**THE PORT AUTHORITY OF NY & NJ**

**ADDENDUM #5**

**TO PROSPECTIVE BIDDER(S) ON CONTRACT # WTCR – W30-2011-31  
WTC REDEVELOPMENT – WTC TOWER 2 PLAZA INTERIM IMPROVEMENTS**

SK-12  
WSP  
2-13-15

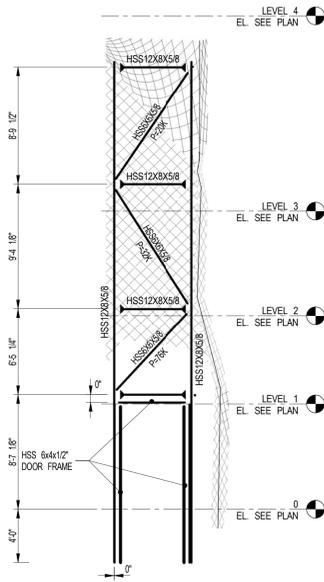
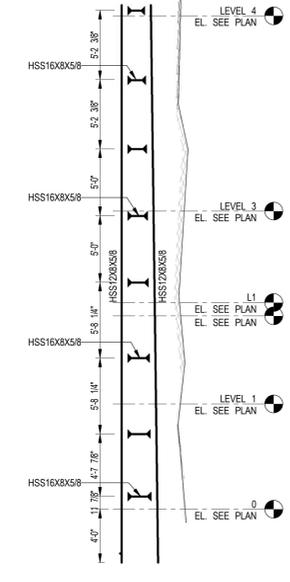
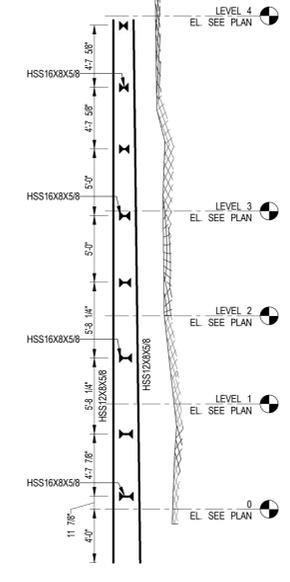
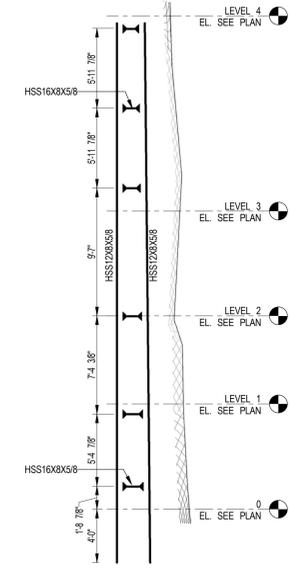
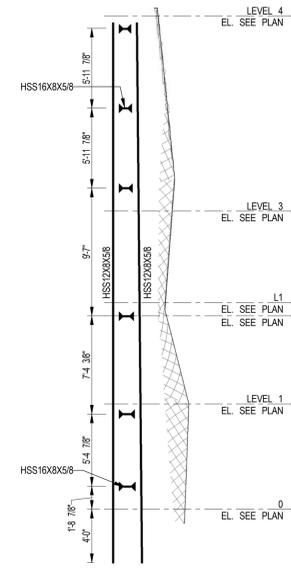
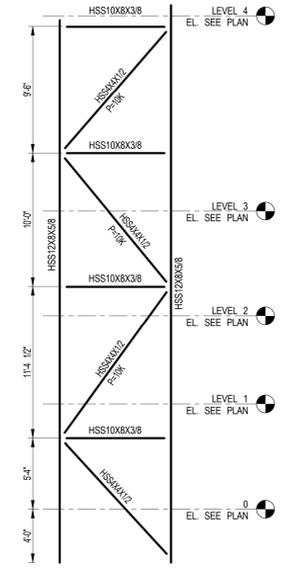
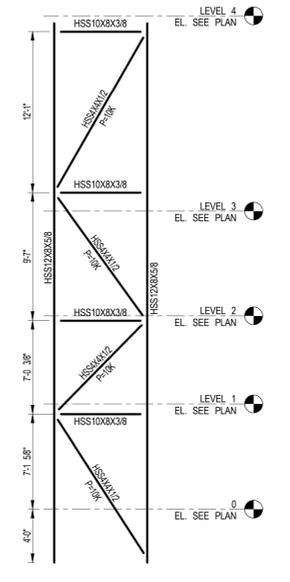
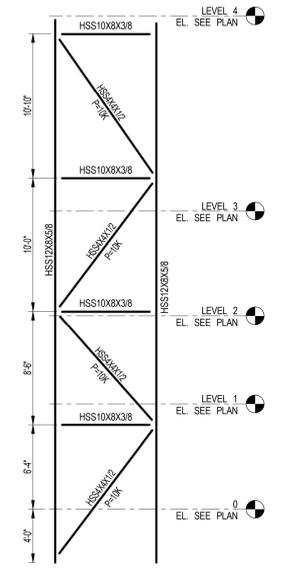
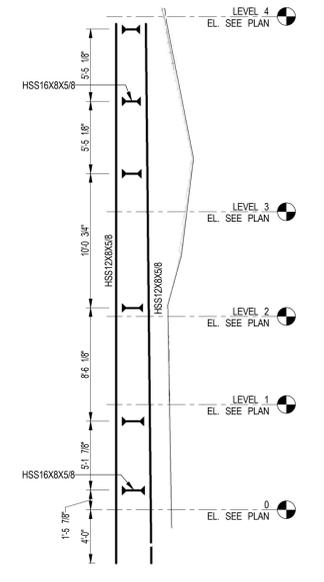
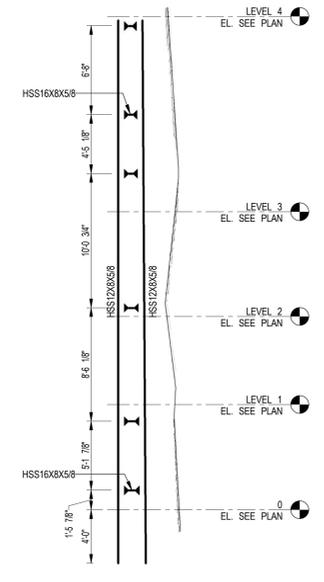
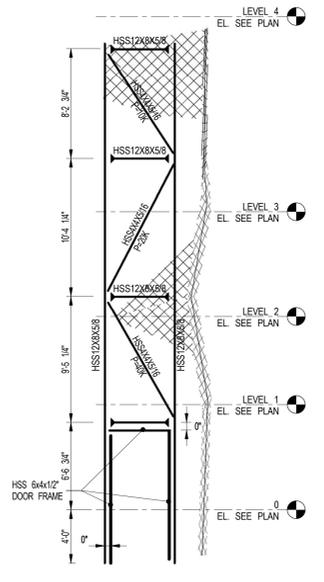
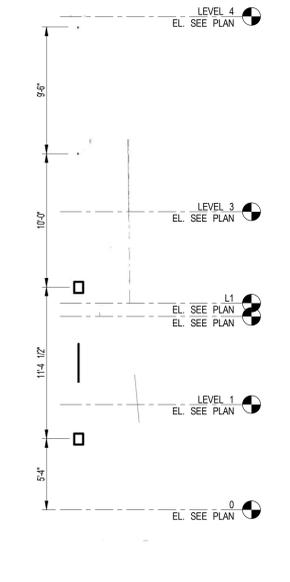
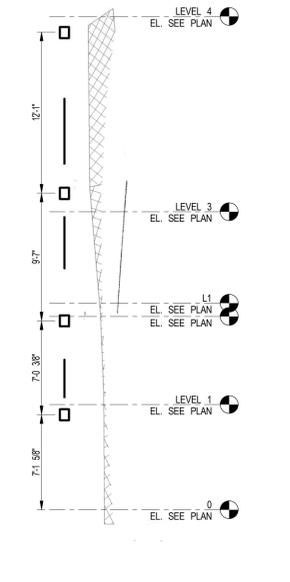
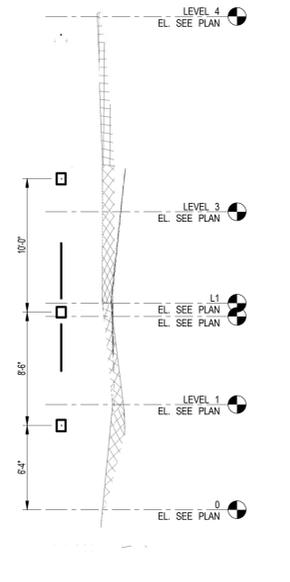
<b>Answer #99</b>	Refer to note 3 on Contract Drawing S-101. We anticipate full penetration welds will be required at all facet point locations of the HSS horizontal sloping members that support the mesh panels (HSS14x10x5/8 and HSS12x6x1/2). All other locations can be fillet welds provided they are designed for the forces shown on the Contract Drawings.
<b>Question #100</b>	On Drawing L-601 at detail 1A "STONE WALL PLANS", at the "PLANS @ SECOND STEPBACK" and at the "PLANS @ FIRST STEPBACK" there are call-outs for 'SECOND STEPBACK CHANNEL' and 'FIRST STEPBACK CHANNEL' respectively. Please provide information as to the size of the channel, the finish, and how it is attached to the structural steel.
<b>Answer #100</b>	Refer to Contract Drawing S-300 for structural attachment details.
<b>Question #101</b>	RE: Structural Drawings (S-100, S-101, S-102) – Please provide horizontal and vertical dimensions on the structural drawings. All of the elevations read "see plan" and there are no horizontal dimensions.

<b>Answer #101</b>	Refer to SK-11 and SK-12 dated 2/13/15.
<b>Question #102</b>	We presume that this bluestone slab is to be installed at the 3 set-back stone wall areas. If so, the bluestone slab dimensions shown on L-102 and L-103 are excessively long at 8'-10", 8'-4", and 12'-3"; being approximately 4'-3", 4'-0", and 3'-9" wide and only 2" thick. Please provide a joint pattern to minimize the length and/or width of these slabs because handling such long, wide, thin stone panels is virtually impossible.
<b>Answer #102</b>	Refer to SK-13 dated 2/17/15.
<b>Question #103</b>	Drawing P.01.01 at the table DRAIN SCHEDULE, DESIGNATION A is for "PLAZA AREA DRAINS"; TOP SIZE 14"; the information is in conflict with the plan view on the same Dwg which says "3" PLAZA DRAIN (510 SQ.FT.)" and in conflict with the CONSTRUCTION NOTES. 2. which calls for "3" PLAZA AREA DRAINS (...TO BE BOTTOM OUTLET TYPE UNITS..."; and in conflict with detail "3 PLAZA DRAINAGE @ PAVED AREAS" which calls for "3" SURFACE DRAIN BODY (510 SQ.FT.); and in conflict with Dwg L-600 detail "5 SIDE OUTLET PLAZA DRAIN". Please clarify.

**TYPICAL PIPE CROSSING**

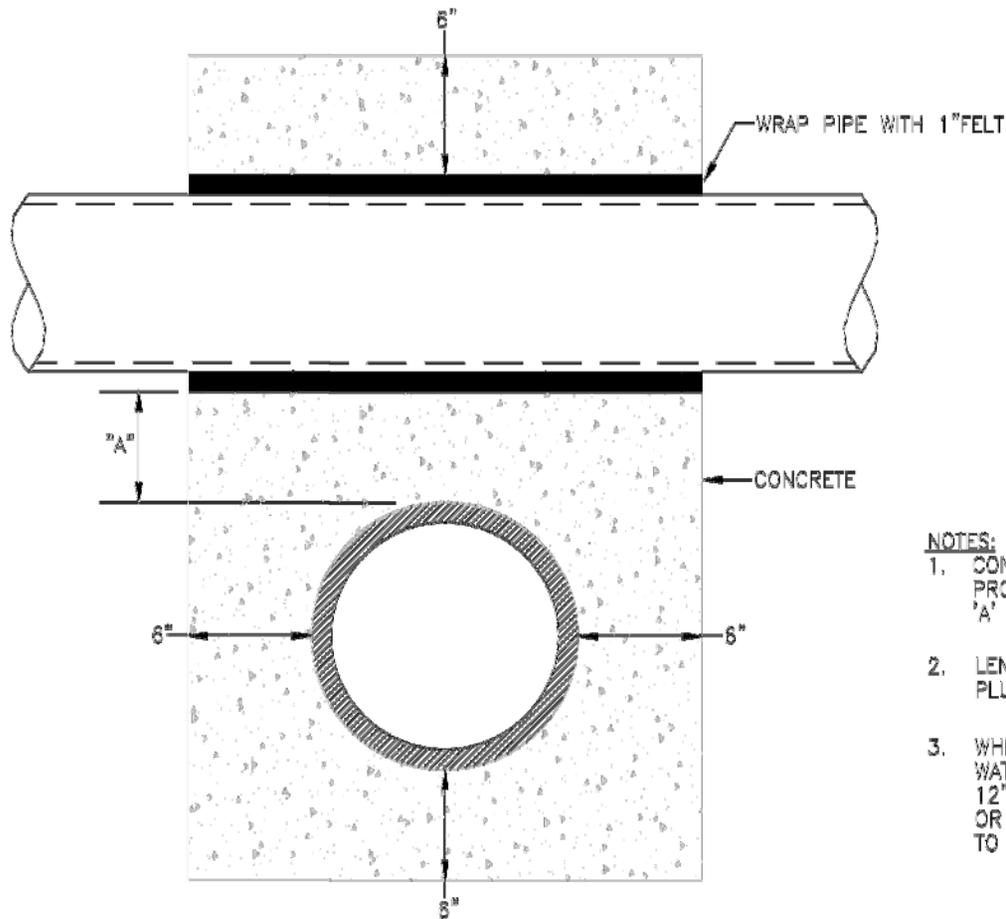
<b>Answer # 96</b>	Please refer to electronic pdf file of drawing, which will portray all information and eliminate any concerns about line weight. Please refer to Detail 2 on Contract Drawing L-600 for further details on "CURB BELOW".
<b>Question #97</b>	On Drawing L-601 at detail 2 "TYPICAL STONEWALL SECTION" at the top it says "STONE WALL BEYOND". Can you please provide more information about how this Stone Wall is installed?
<b>Answer #97</b>	Refer to SK-4 and SK-5 dated 2/10/15 for additional details.
<b>Question #98</b>	Drawing P.01.01 at the CONSTRUCTION NOTES. "1. STORM AND CW PIPING TO RUN BURIED THROUGH INFILL SLAB. REFER TO ARCHITECTURAL SET FOR TRENCHING DETAILS". We cannot find trenching details on either A.01.100 or A.03.101. Are there other architectural drawings?
<b>Answer #98</b>	Refer to Contract Drawing L-600 for trenching and pipe embedment details. Also refer to SK-14 dated 2/17/15 for a typical pipe crossing detail.
